**SUBDIVISION REVIEW SHEET****CASE NO.:** C8-2021-0078.1A**COMMISSION DATE:** Mar. 29, 2022**SUBDIVISION NAME:** Cearley Community Subdivision**ADDRESS:** 1601 Cedar Bend Dr**APPLICANT:** Cearley Tract Development, Inc. (Garrett Martin)**AGENT:** Connor Overby, P.E. (Atwell, LLC)**ZONING:** SF-4A-CO (single family residence)**AREA:** 29.17 acres**LOTS:** 130**COUNTY:** Travis**DISTRICT:** 7**WATERSHED:** Walnut Creek**JURISDICTION:** Full Purpose**SIDEWALKS:** Sidewalks will be constructed along Cearley Dr, Kit Cove, Fennec Way and Corsac Way.**DEPARTMENT COMMENTS:**

CITY OF AUSTIN –DEVELOPMENT SERVICES DEPARTMENT  
SUBDIVISION APPLICATION – MASTER COMMENT REPORT

CASE NUMBER: C8-2021-0078.1A  
UPDATE: U1  
CASE MANAGER: Joey de la Garza      PHONE #: 512-974-2664

PROJECT NAME: Cearley Community Subdivision Final Plat  
LOCATION: 1601 CEDAR BEND DR

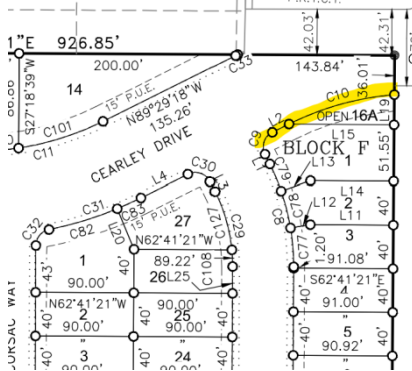
ATD 2. Sidewalks are required on both sides of Cearly Drive, Corsac Way, Fennec Way, and Kit Loop. Identify the location of the sidewalks by a dotted line on the final plat and include the sidewalk symbol within the Legend. LDC 25-6-351. TCM, 4.2.1.

**U1: Please add a sidewalk symbol to the location highlighted in the image below along Cearly Drive.**
